Access Compliance Report

Public Rights-of-Way

Intersection ID: 2919	Main Street: GREEN_HEDGE_AV	Cross Street: MADISON_PARK_DR	Location: W
ADA ID: A0B3E7F647D3	Ramp Type: BlendTrans1	Initial Pass/Fail: Pass	Overall Compliance: No
Severity Score: 22.5			
Codes/Mitigation Info/Possible Solution		Field Measurements/Component Compliance

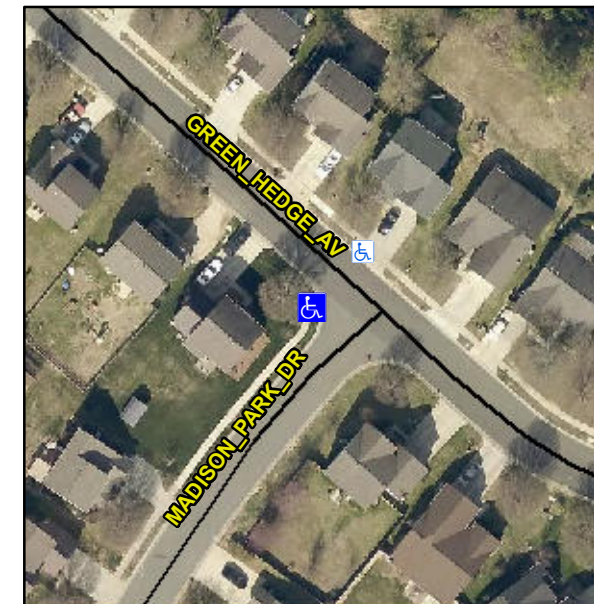
CURB GAP 2.0

R304.2.1, R304.5.3, R305.1.4, R305.2, R302.7.2, R304.5.4

Compliance	Description	Data	Compliance	Description	Data
N/A	Ramp Length (in)	47.0	Yes	BlendTrans Slope (%)	0.9
Yes	Ramp Width (in)	48.0	Yes	BlendTrans XSlope (%)	0.9
N/A	Flare Type LT	Sloped	N/A	Flare Type RT	Sloped
N/A	Flare Slope LT (%)	10.4	N/A	Flare Slope RT (%)	8.0
N/A	Flare Traversable LT?	No	N/A	Flare Traversable RT?	No
No	Landing Length (in)	47.0	Yes	DWS Provided?	Yes
Yes	Landing Width (in)	67.0	Yes	DWS Contrast?	Yes
Yes	Landing Slope (%)	1.2	Yes	DWS Length (in)	25.5
No	Landing X Slope (%)	2.1	No	DWS Full Width?	No
N/A	Landing Curb? (Y/N)	No	No	DWS Offset (in)	4.0
N/A	Shared Landing?	No			
Yes	Gutter Ponding?	No	No	Gutter Slope (%)	5.3
No	Gutter Lip Ht (in)	2.0	Yes	Gutter X Slope (%)	0.0
N/A	Painted X Walk1?	No	N/A	Painted X Walk2?	N/A
	X Walk 1 Direction	To NE		X Walk 2 Direction	N/A
	X Walk 1 Width (in)	N/A		X Walk 2 Width (in)	N/A
	X Walk 1 Slope (%)	2.9		X Walk 2 Slope (%)	N/A
	X Walk 1 X Slope (%)	4.4		X Walk 2 X Slope (%)	N/A

Remove & Replace Curb Ramp With Two New Directional Ramps or Equivalent. Remove & Replace Gutter.
